From: [Karen Nielsen](#)
To: [Plan Commission Comments](#)
Subject: 6/10 Mtg: Agenda Item #25
Date: Monday, June 10, 2024 2:58:29 PM

Comments on Rezoning and Conditional Use for 6610-6706 Old Sauk Road for Plan Commission Meeting June 10, 2024

Response to Staff Report

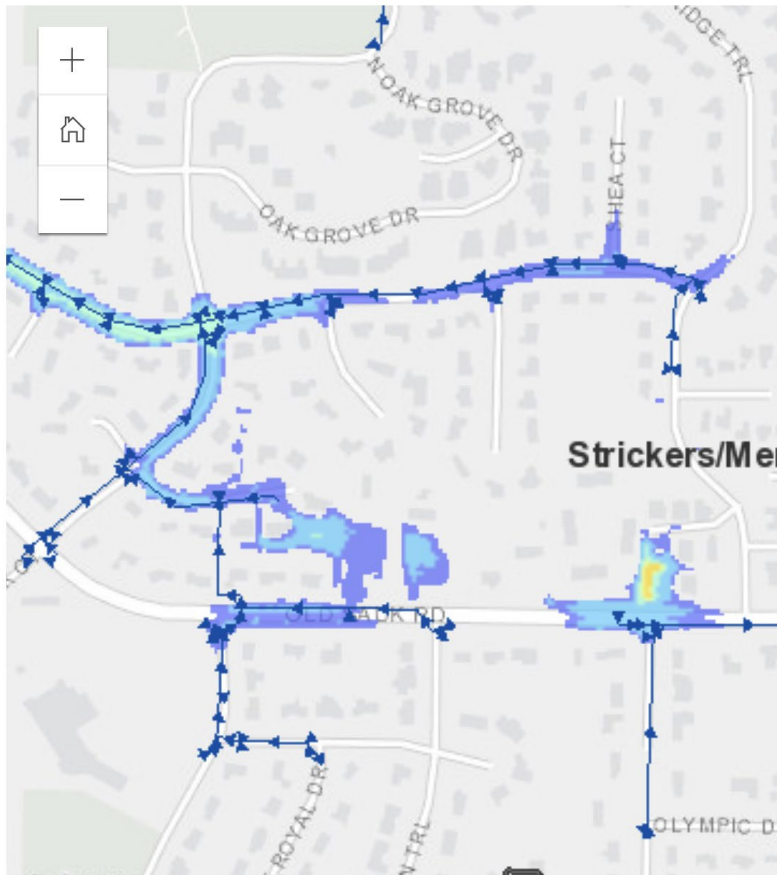
"The areas with silt loam seams that have an infiltration rate of .13-.15 in/hr can have the infiltration rate improved to .5 in/hr by excavation/turning of the silt loam seams."

From my perspective this design is in serious trouble and will not perform. Soil turning is unproven and not guaranteed to solve the problem. Perhaps the only way to know if it will work is to fully construct the system and then have a water test to prove if required infiltration rates have been met, if not no permit is issued.

“It should be noted that to meet water quality, infiltration, and volume requirements the report notes they plan to “excavate and turn” the soils at the bottom of the infiltration systems. This is proposed to be done to allow the site to reach the design infiltration rates used. I am not aware of standards for turning soils. Additional details/information will be required on how this will be completed and how it will be verified in the field that these infiltration rates have been met. Madison General Ordinance 37 provides for a requirement to certify that the stormwater management plan has been constructed in accord with the design. This provision is not often required but it would be mandated in this case. However, again it is noted that there will be additional information required on how they plan to verify that design infiltration rates proposed are met in the field and a post construction certification will be required as allowed by MGO 37.”
